State of Alaska
Department of Fish and Game
Habitat and Restoration Division

Nomination for Waters
Important to Anadromous Fish

Anadromous Water Catalog Number of Waterway **102-70-10320**

Stream 102-70-10320 Nomination Correction

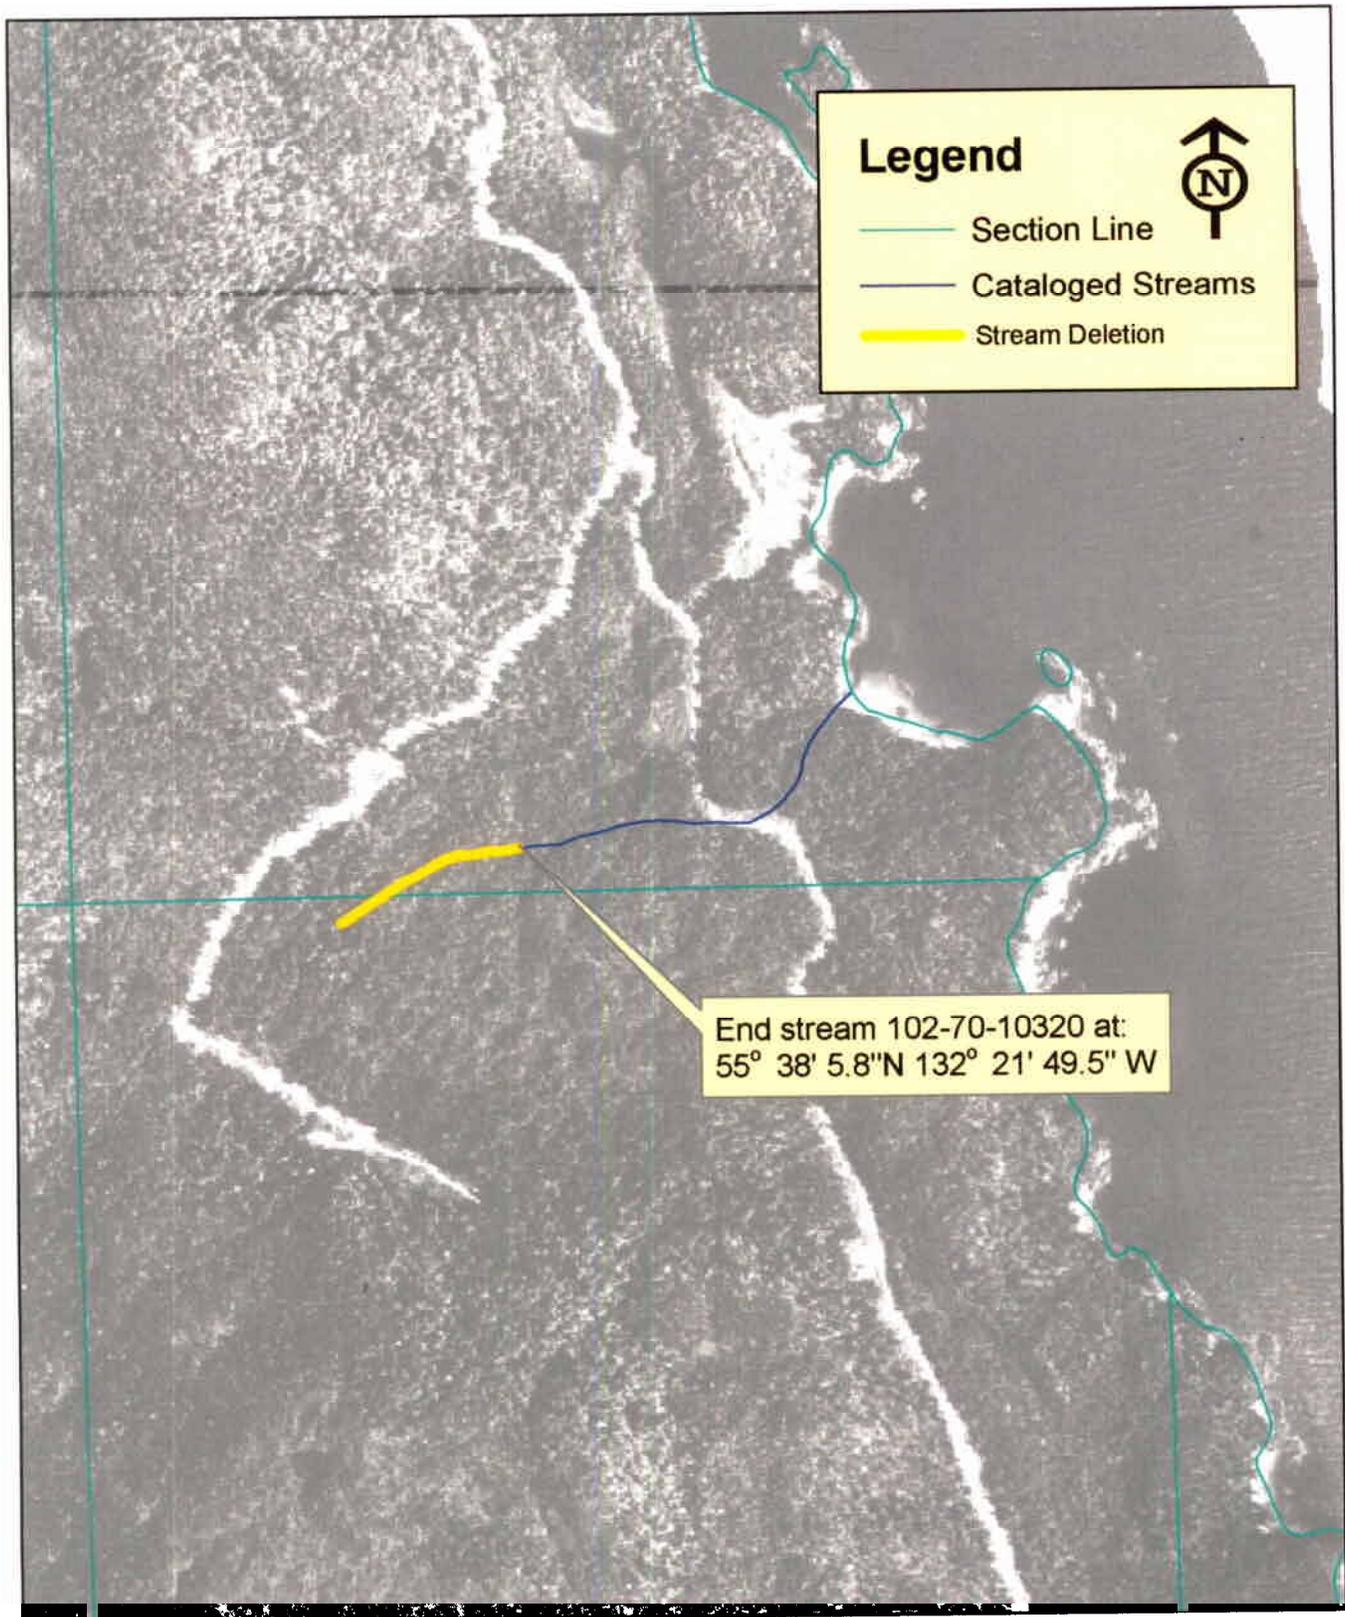
Comments: On February 1, 2005, as part of a FRPA inspection, I observed a fish barrier waterfall located at NAD 27 GPS Point, 55°, 38', 05.8" N, 132°, 21', 49.5" W. This high velocity, bedrock waterfall has an estimated gradient of 30 percent and an approximate length of 200 feet. This stream is cataloged as anadromous beyond this waterfall and should be adjusted to reflect this fish barrier. The cataloged stream should terminate approximately 0.5 miles downstream.

2/1/05 Tel, tai 102-70-10320
55° 38' 05" N Fall on stream
132 21' 49.5

~ Grad = 30%
~ 200ft long

Add baseice 102770-10320
Shorten extent of stream

Action: Remove the upstream portion of stream 102-70-10320 up to 55°, 38', 05.8" N 132°, 21', 49.5" W.

Add FISH BARRIER
